# CITY OF ALBUQUERQUE

**Re: GAHP Casa Feliz  
418 San Pablo Street SE  
Request Permanent C.O. - Accepted  
Engineer's Stamp dated: 12-18-15 (L19D073B)  
Certification dated: 4-12-17**

**From:** Harmon Rita T. <rharmon@cabq.gov>  
**Sent:** Tuesday, May 03, 2016 9:44 AM  
**To:** Dave Aube  
**Subject:** RE: Casa Feliz L19D073A-I

PROJECT NAME  
CASA FELIZ

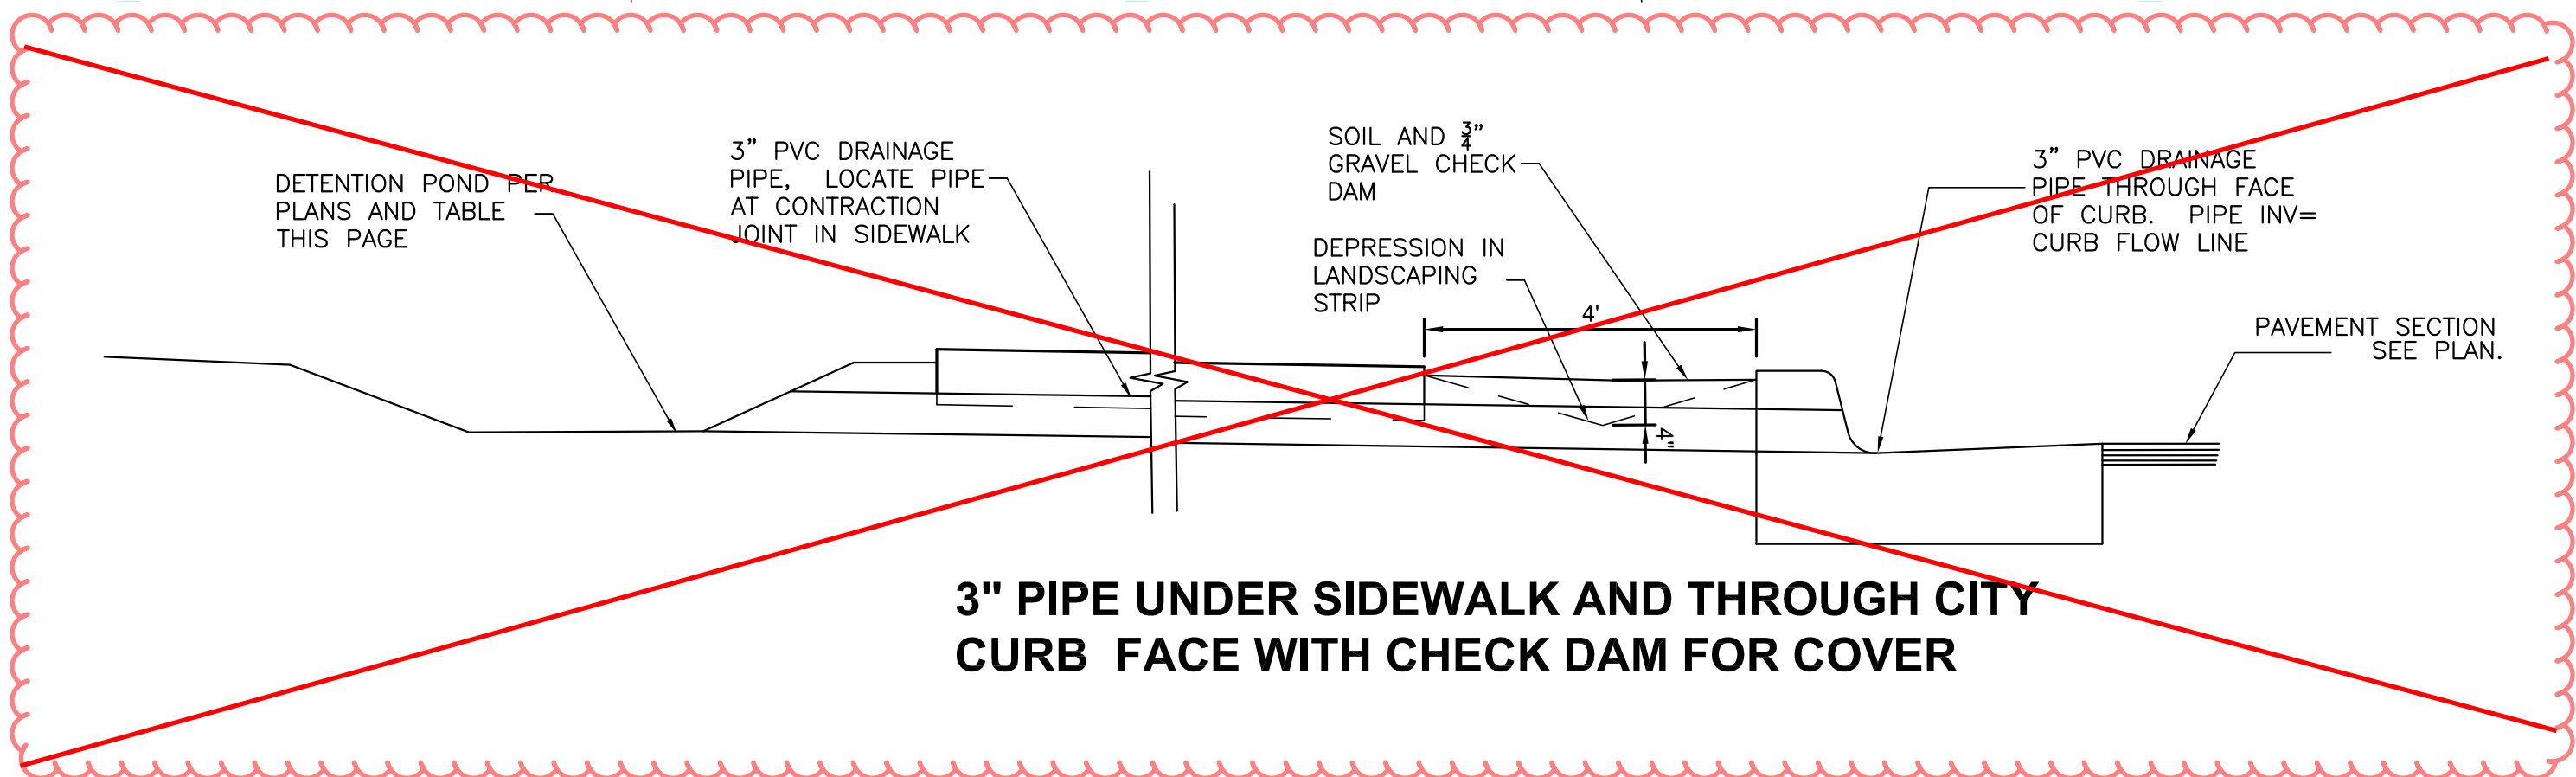
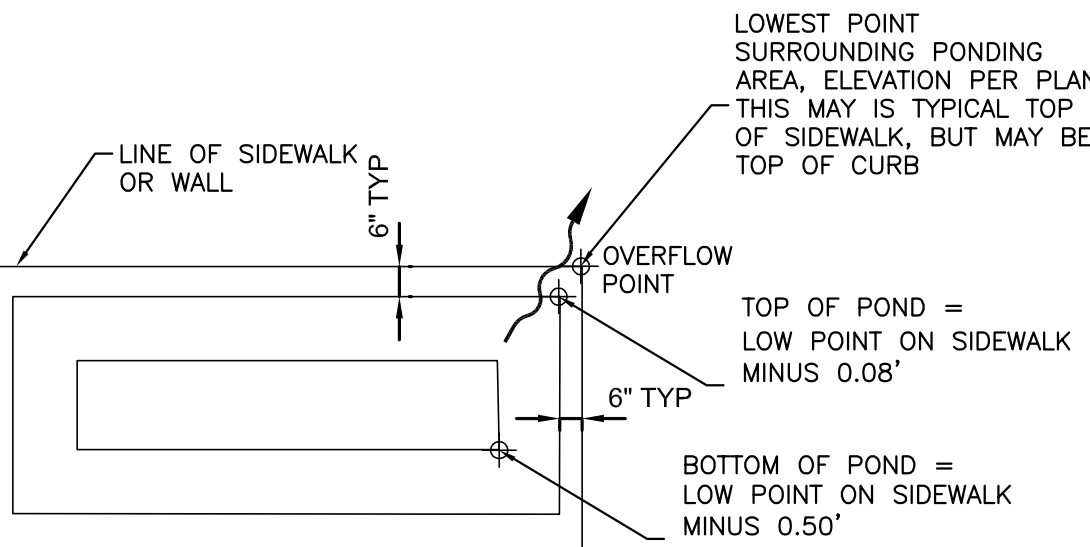
This detail requirement was removed after release of the building permit. Please refer to the email correspondence with City of Albuquerque Hydrology Staff dated May 3, 2016 attached with this submittal.

I agree that the 4" PVC pipes should be eliminated, and that the first flush ponds should overflow across the sidewalks in a sheet flow manner. Rather than resubmit a revised grading plan, with a new approval, this email serves as Hydrology's acceptance of this change and will be added to the drainage file to document the change. Please be sure to note the change on the As-built drawing when requesting C.O.

ENLARGED  
SITE DRAINAGE PLAN  
NORTHERN PART OF  
BUILDING B

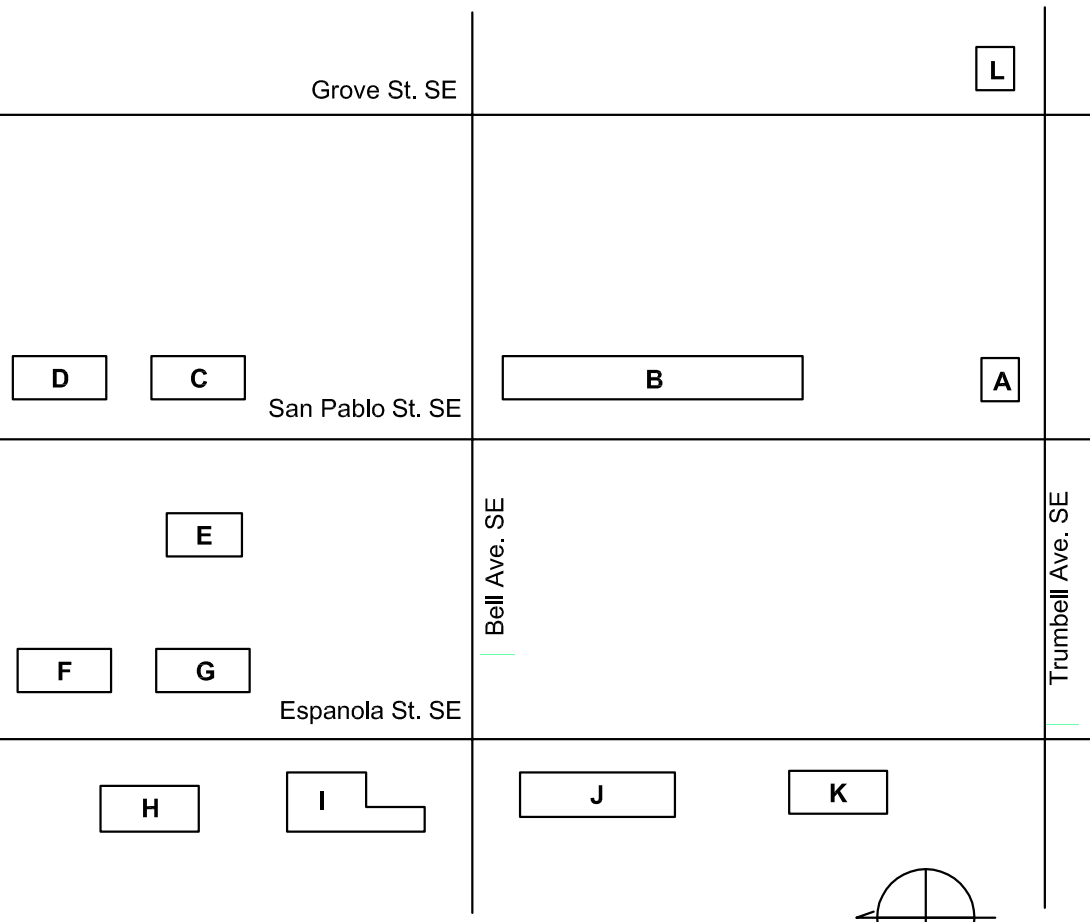
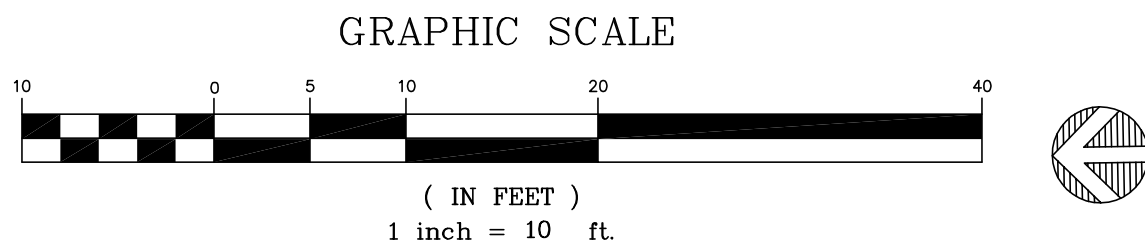
This pond eliminated.
